TCS Performance Products

Dodge 4X4 29 Spline Input Shaft Modification Requirement

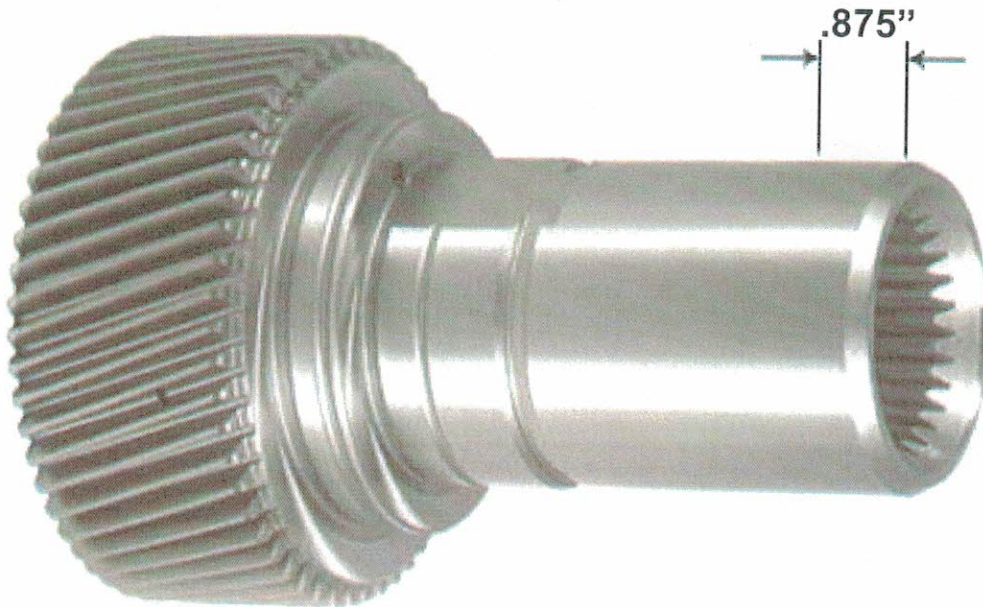
Installation of the TCS Extra Heavy Duty 29 Spline 4X4 Output Shaft #618102 requires the shortening of the OEM Input Shaft #05086311-AA. See the diagram below for details.

Shorten the Dodge OEM
4X4 29 spline input shaft #05086311-AA
then machine ID & OD chamfers
